Village of Bayside
9075 N Regent Road
Architectural Review Committee Meeting
September 12, 2022
Village Board Room, 6:00pm

ARCHITECTURAL REVIEW COMMITTEE AGENDA

Attention:
Village of Bayside, WI
Architecture Review Committee

| PROJECT/SITE OWNER: Arthur Kathan PROJECT ADDRESS: 8581 N Pelham PKWY | PROJECT SUMMARY: Replacing double front doors to a single front door with two sidelights. |

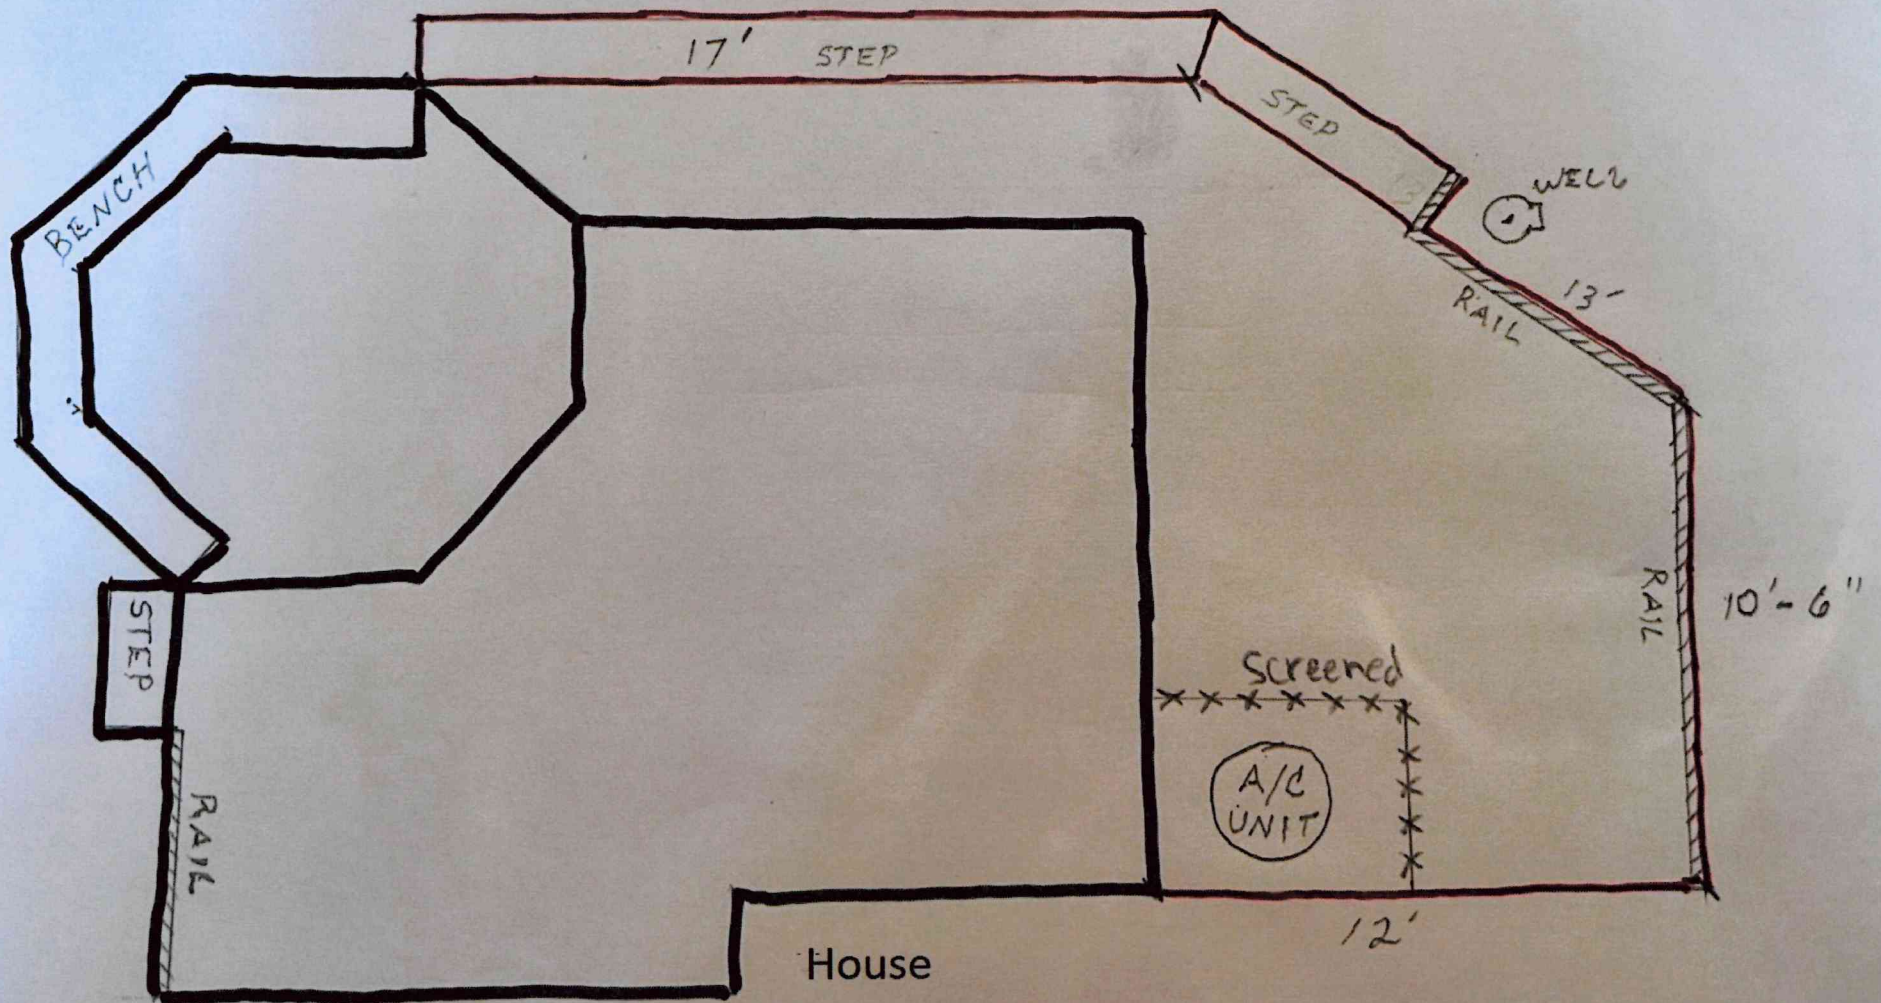
I have reviewed the proposed deck, for compliance with the Village's ordinances and have determined the following for consideration

There are no issues with this application.
